PERMIT SET

PGM

Project Type: TENANT FINISH

Issue: Date:
Permit Set 02.10.26
Plan Review Revisions 02.23.26

HOLLOW METAL DOOR
FRAME JAMB DETAIL

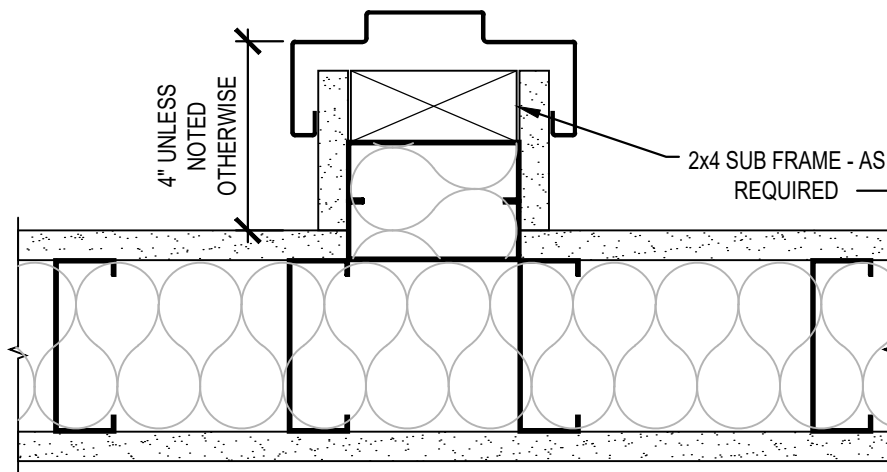
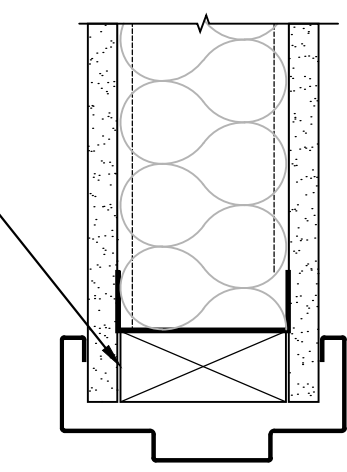
COMMENT #1: WALLS WITHIN 2' OF SERVICE SINKS, URINALS, AND WATER CLOSETS MUST BE PAINTED WITH EPOXY-BASED PAINT UP TO A MINIMUM OF 4" A.F.F., IF NOT COVERED WITH FRP.
COMMENT #2: PAINT AND INSTALL RUBBER COVE BASE ON WAREHOUSE SIDE OF OFFICE AREA (GYPSUM BOARD WALLS).
